Green Star – Office Interiors v1.1

Indoor Environment Quality
IEQ-13 Air Supply Ductwork

CIR Response:**IEQ-13 'Air Supply Ductwork'**

Project Name: GBCA Fitout (GS412I)		Date: 13/12/2007
<input type="checkbox"/> Green Star – Office Design v1 <input type="checkbox"/> Green Star – Office Design v2 <input type="checkbox"/> Green Star – Office As Built v1 <input type="checkbox"/> Green Star – Office As Built v2 <input type="checkbox"/> Green Star – Office Interiors v1 <input checked="" type="checkbox"/> Green Star – Office Interiors v1.1 <input type="checkbox"/> Other _____	Submitter Name, Organisation and Position: Richard Palmer, Advanced Environmental, Environmental Design Consultant	
	Are you an Accredited Professional? Yes	
	Green Star Credit for which CIR is sought: IEQ – 13	
	<p>What precludes the project from meeting the Credit Criteria?</p> <p>The credit criteria requires that all ductwork is cleaned to remove dirt, dust and mould prior to occupancy. If the ductwork is new, this credit is “Not Applicable”.</p> <p>This project has a combination of old and new ductwork. Therefore, an interpretation is required to determine the appropriate course of action to ensure the aim o

**DUCTWORK LAYOUT
L15**

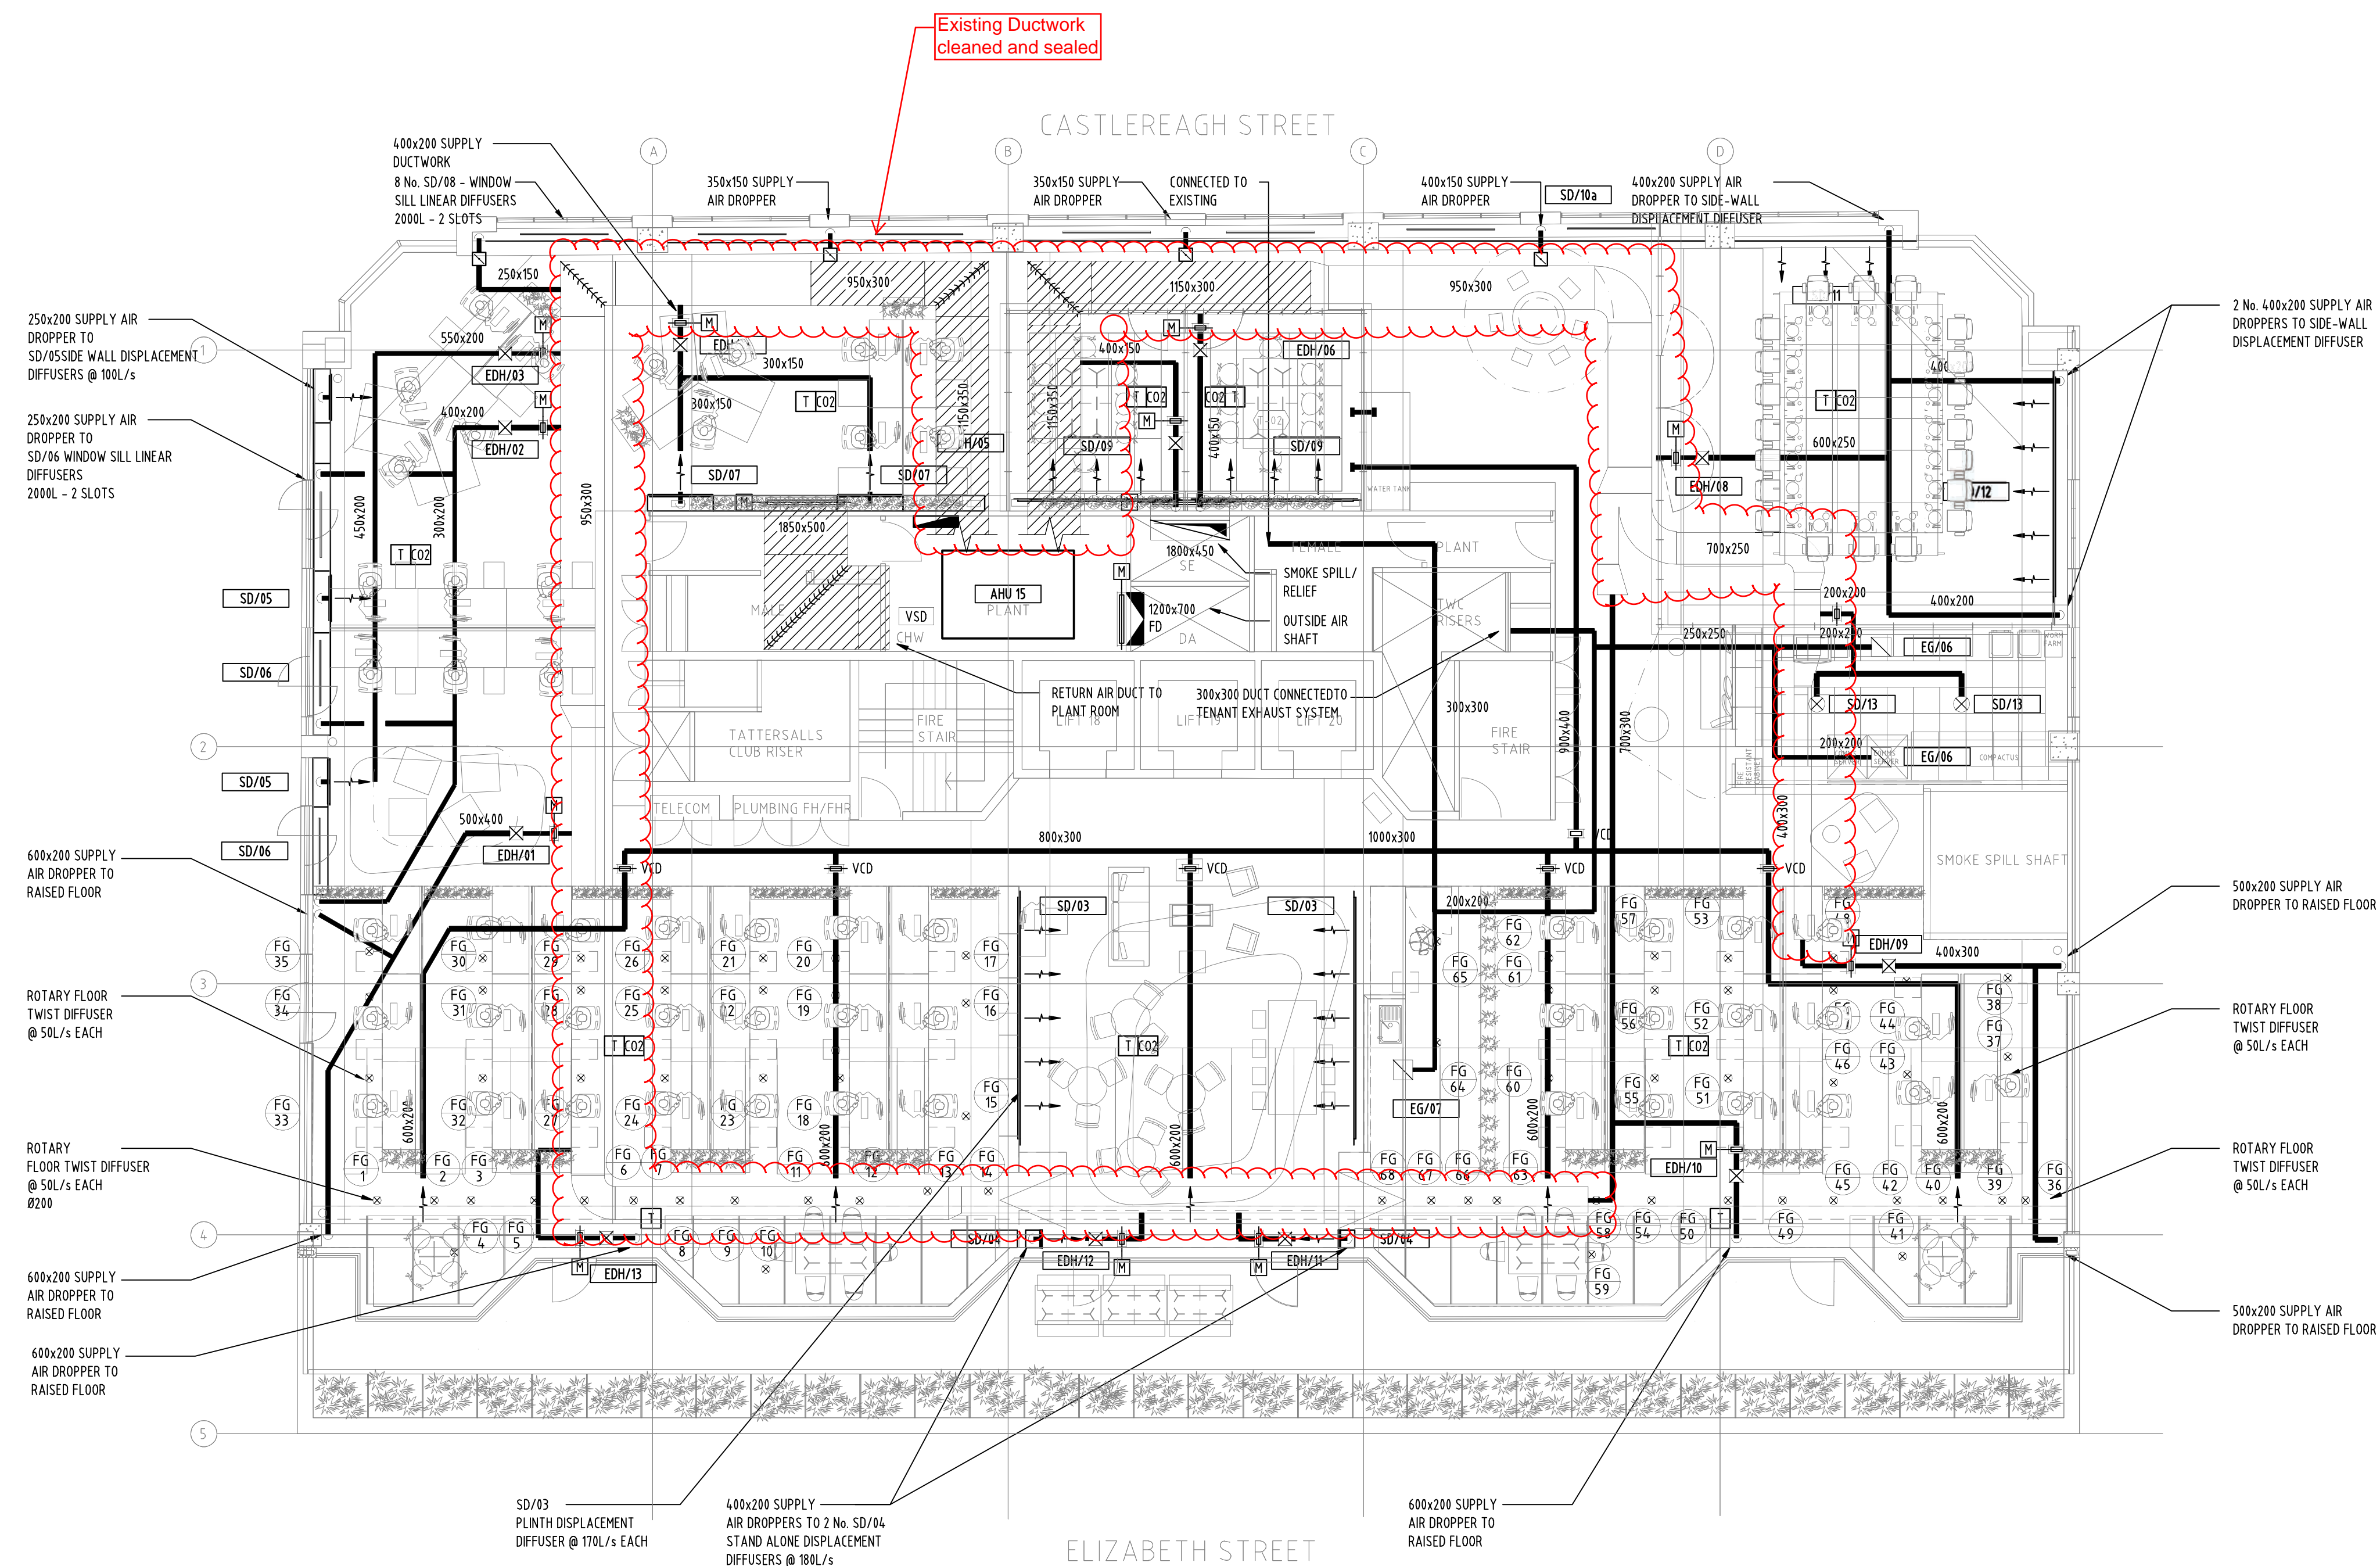
<p>Interpretation Requested:</p> <p>There is a mixture of new and existing ductwork in the fit-out. The existing ductwork has been cleaned and sealed after all fit-out works on that ductwork have been completed. Sealing the ductwork ensured no particulates entered the cleaned ducts during further fitout works.</p> <p>The new ductwork was added to the cleaned and sealed ducts during further fit-out works.</p> <p>This means that all ductwork in the fit-out was either cleaned or new.</p>		
Does the proposed solution meet the Aim of the Credit?		Yes
Does the CIR propose alternative yet equivalent compliance with the Aim of the Credit?		Yes
Is the proposed solution a building attribute rather than subject to operations?		Yes
<p>Documents Attached:</p> <ul style="list-style-type: none"> - Statement from the mechanical servicer stating all existing ductwork was cleaned and sealed. - Photographs of the sealed ductwork demonstrating no particulates could enter the ductwork during further fitout works. - Statement from the builder demonstrating that all existing ductwork was sealed and all subsequent ductwork was new. - Mechanical drawings showing existing (cleaned and sealed) and new ductwork.

Technical Clarification: A project may claim 1 point where a combination of both new and existing ductwork is used, provided that the project can demonstrate that all existing ductwork was cleaned before the new ductwork was added and that all ductwork was sealed upon completion of ductwork fitout works.
